Amendments to the Drawings

Remarks/Arguments

Marked up drawing
Serial No. 09/709,237

Fig. 5

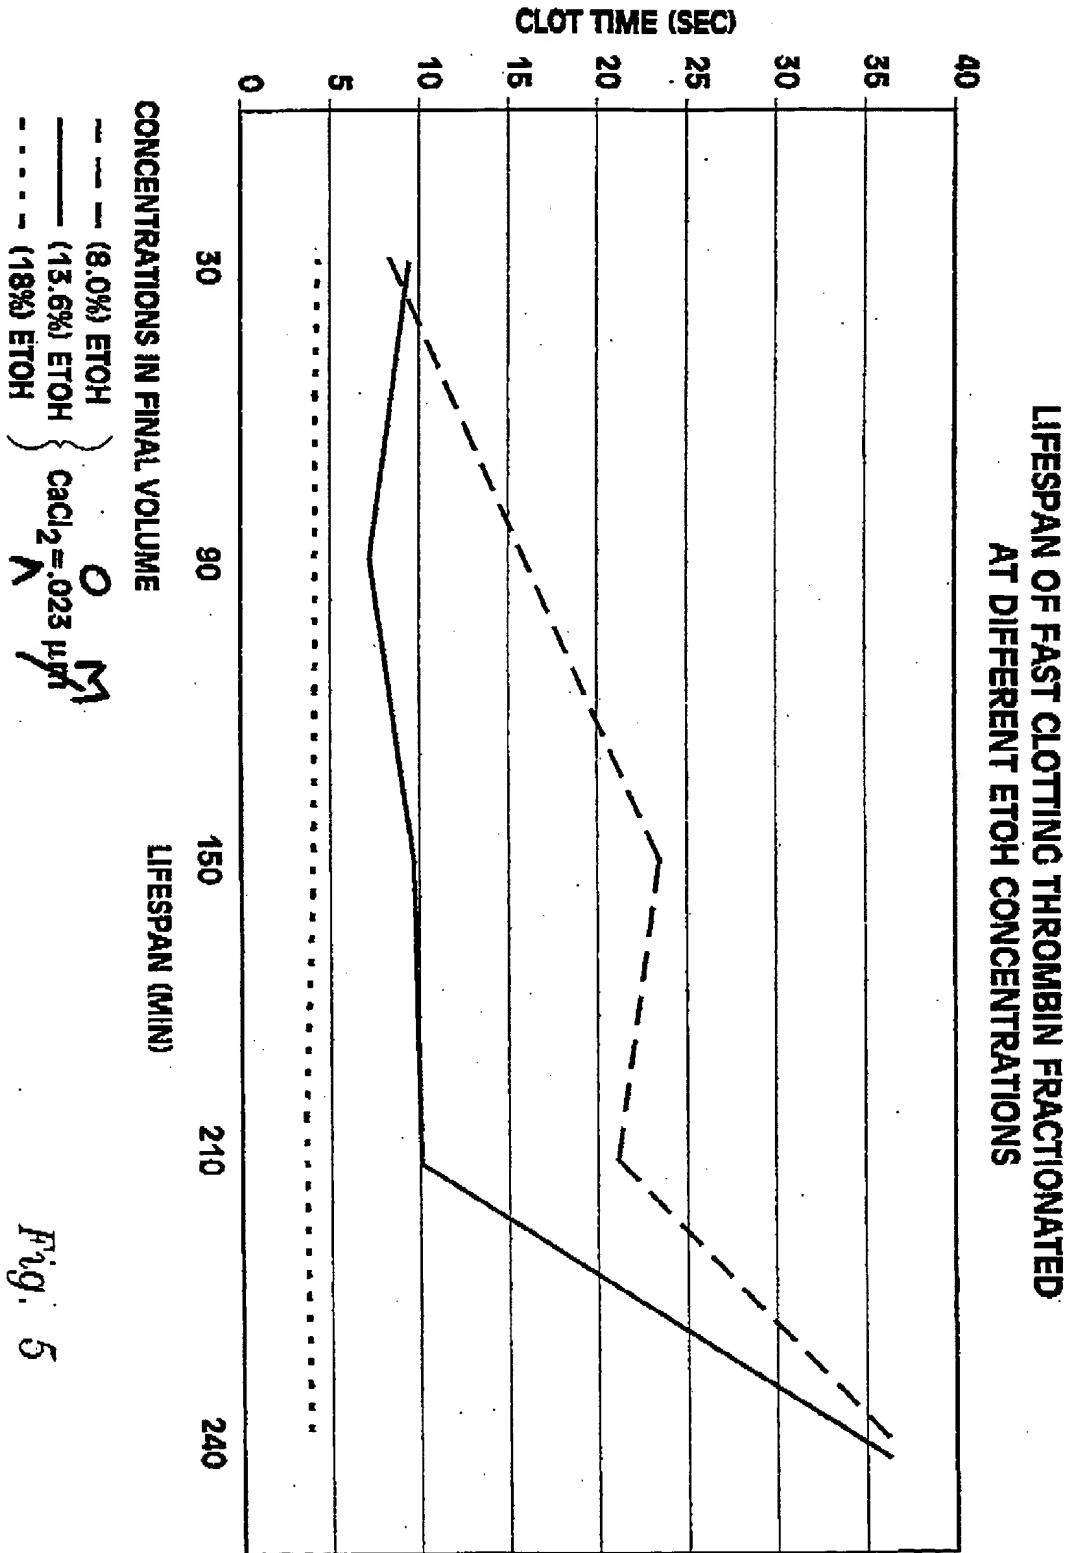
Figs 5 and 6 have been corrected in response to the Examiner's objections, to show the proper abbreviation for micromolar. Figs. 5 and 6 now read " μM " instead of "mM."

Applicants have also amended Figs. 5, 6, 7, 8, 9, 10, and 11 to refer to "0.023", "0.011", and "0.045" instead of ".023", ".011", and ".045", respectively to add a "0" in the ones column for clarity and ease of reading.

The Examiner has objected to Figs. 5 and 6 on the grounds that they refer to the concentration of calcium chloride in units of " μm " which is an incorrect abbreviation for micromolar (μM). (Office Action, page 3, paragraph 6). Applicants appreciate the Examiner's notation of this error. Applicants have corrected Figs. 5 and 6 to read " μM "

Fig. 7

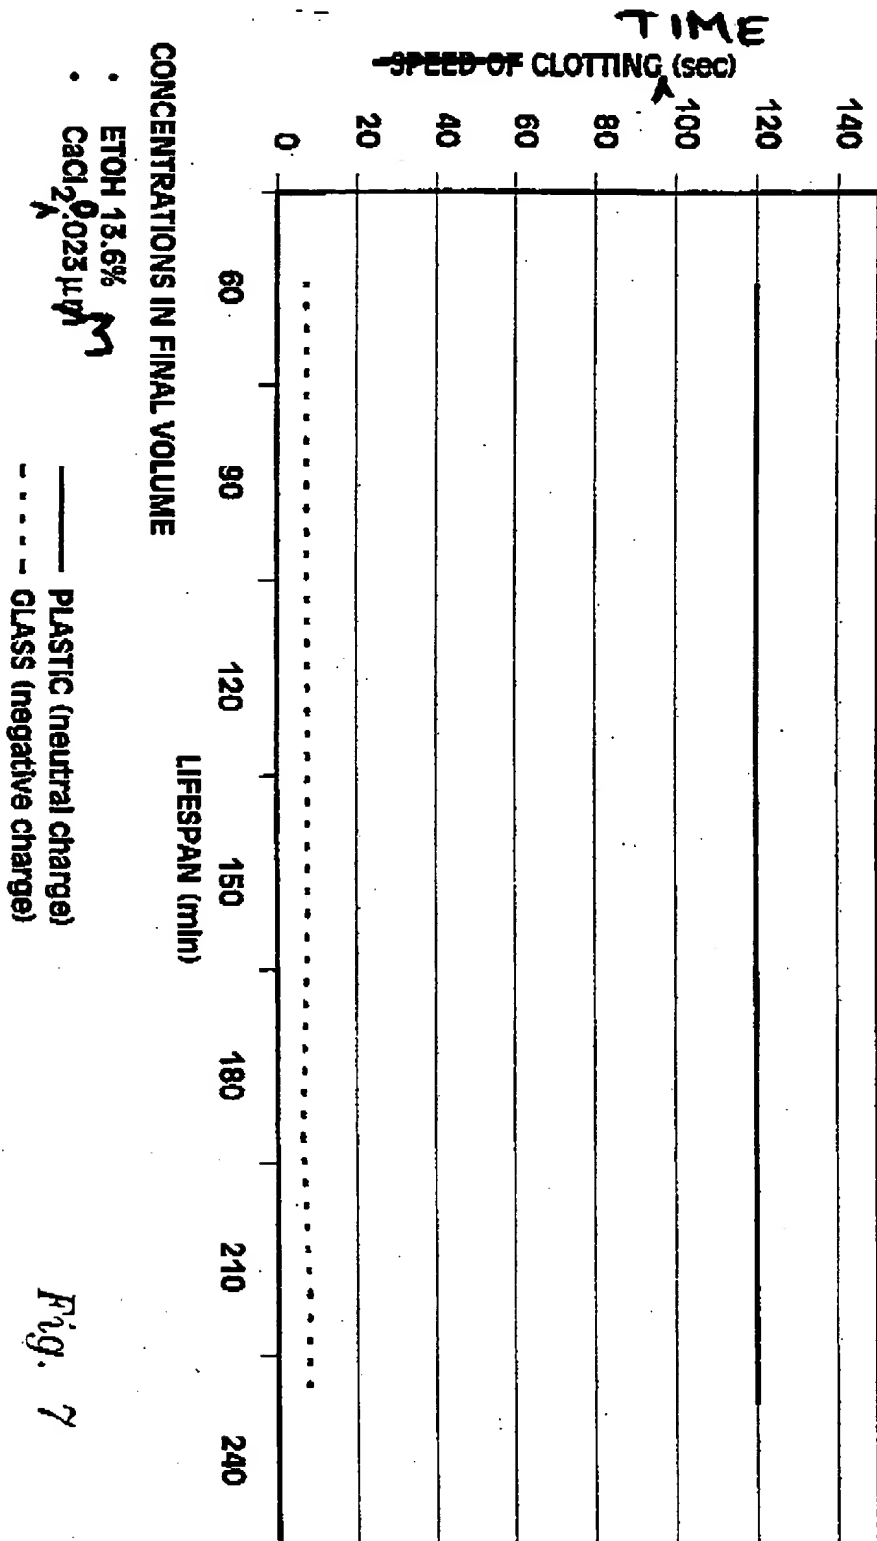
In addition, applicants have corrected Figs. 7, 8, 9, 10, & 11, which also contain the same error. These figures now read " μM " instead of "mM."

Applicants have amended the title of Fig. 7 to change "clotting speed" to "clotting time." Fig. 12 has also been amended to add a label to the Y axis of "Clotting Time (Sec)", which was inadvertently omitted in the submission of formal drawings.

In addition, applicants have corrected the title of Fig. 7 to change "clotting speed" to "clotting time" and Fig. 12 to add a label to the Y axis of "Clotting Time (Sec)". The omission of the label on the Y axis of Fig. 12 was an inadvertent omission in the submission of formal drawings, as Fig. 12 as originally submitted included this label.
